**Environmental Impact Statement
Assessment Report under the
*Environmental Protection Act 1994***

for the Sarsfield Expansion Project
proposed by Carpentaria Gold Pty Ltd

Prepared by: Statewide Environmental Assessments, Department of Environment and Heritage Protection

Figure 2 Contaminated groundwater mound under existing TSF

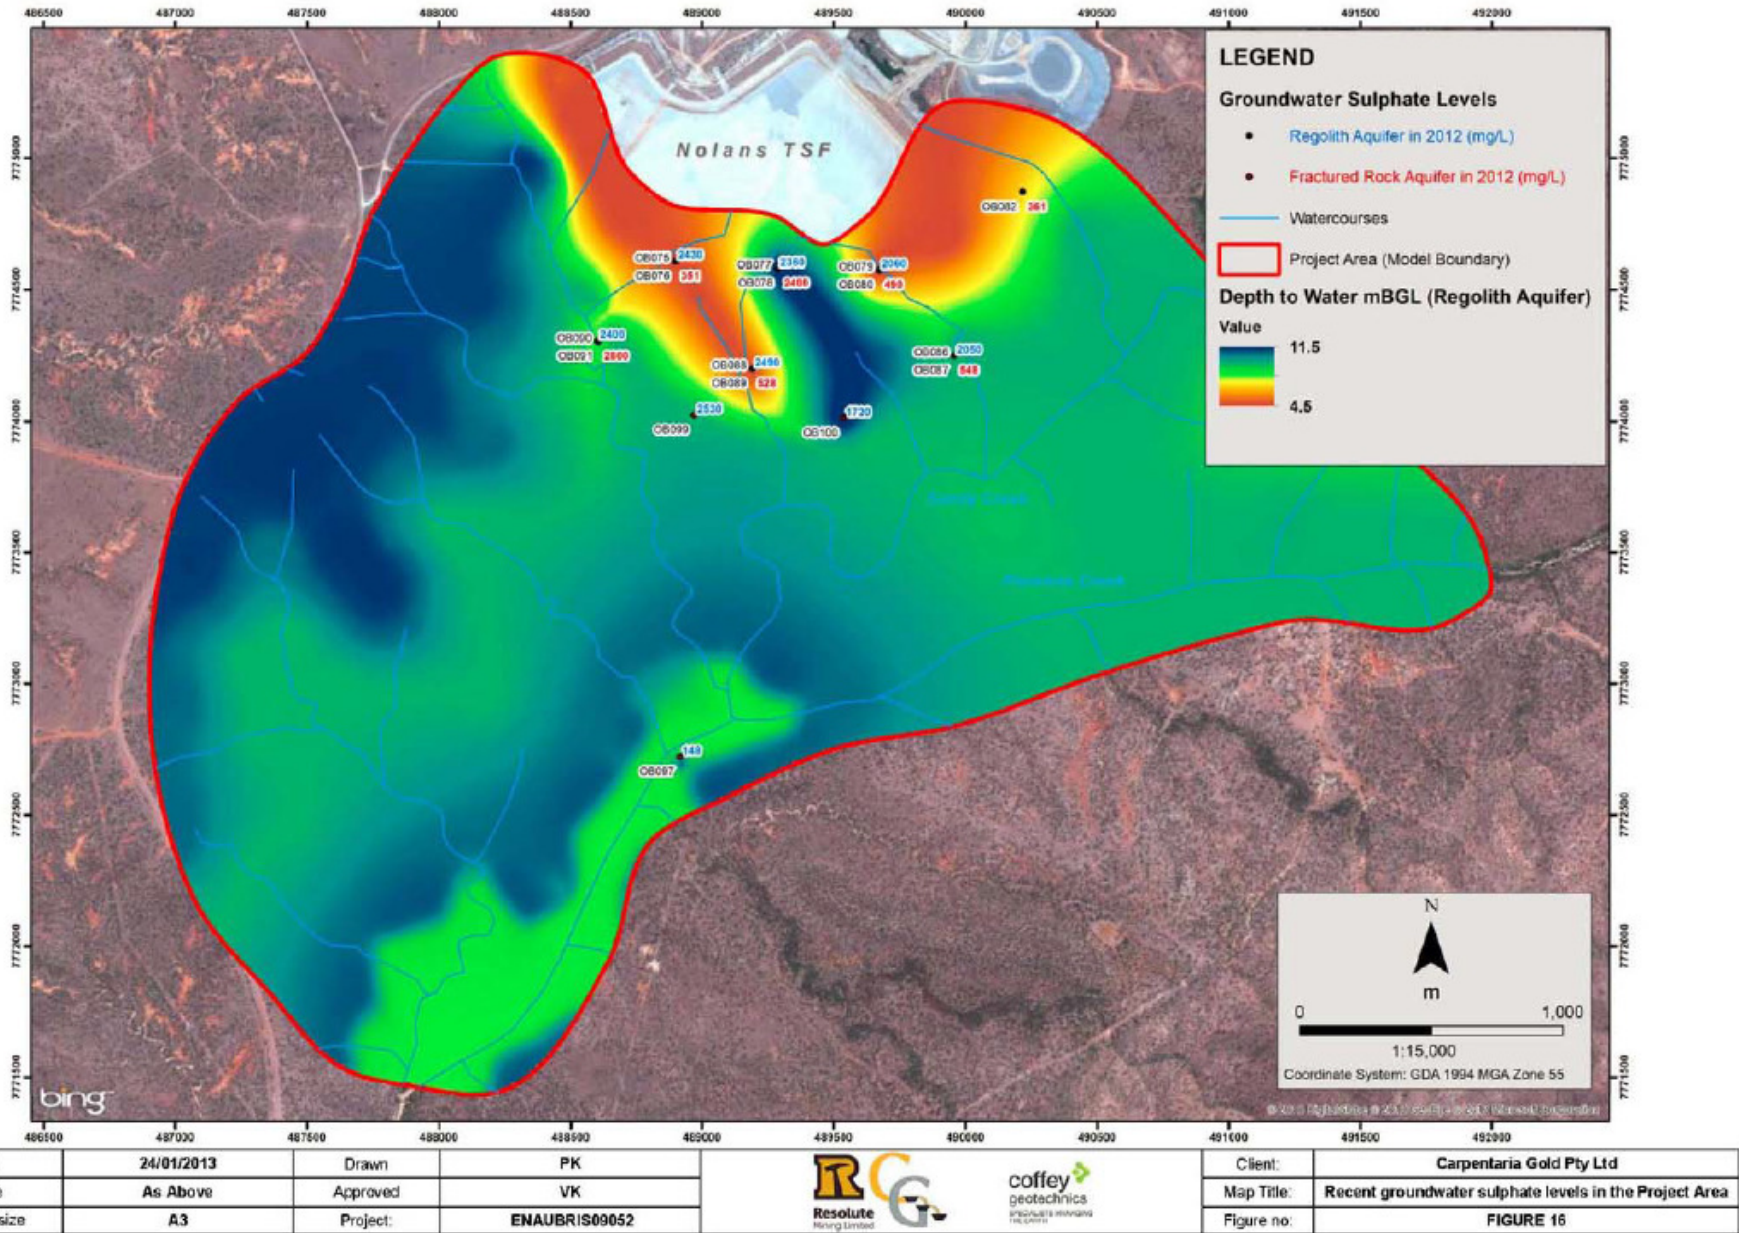
There is an ongoing significant leakage of contaminated leachate from the existing unlined Nolans TSF, which has resulted in a significantly contaminated groundwater table/mound developing under and downstream of the Nolans TSF (refer to figure 2 extracted from attachment 5 of the SEIS). Surface flows of this contaminated groundwater are also recorded as flowing into the adjacent Sandy Creek.

As a consequence, the monitoring and management of seepage and leakage of contaminants to surface or groundwater from the proposed TSF and project works must be able to separately identify between existing contamination and contamination from the new facilities and operations. In addition, the overall performance management of both the proposed TSF and the existing TSF must be coordinated and delivered in such a way that all relevant environmental values are protected. The EIS states that dewatering bores are proposed around the toe of the Sarsfield TSF to continue remediation of the contaminated groundwater. The EIS also states that these bores would also assist in recovery of leakage from the new TSF if the liner becomes compromised. The number and location of the bores is not defined in the EIS and is stated as being subject to further detailed geotechnical investigation. Resolving the number of bores, their configuration and their operation is critical prior to considering approval of the project

The proposal to expand the operation, including through construction of a large TSF immediately adjacent to the existing TSF and above the contaminated groundwater mound (refer to figure 2) introduces a major compounding issue for this project. Potential impacts to groundwater from the new TSF is made much more difficult because, to be effective, performance monitoring of the new facilities must be able to discriminate new leakage from the existing contamination. To protect the environment, there is little that can be done practically to repair a leak in the liner or dewater the tailings should a leak develop. Further contamination of groundwater and surface water is clearly unacceptable.
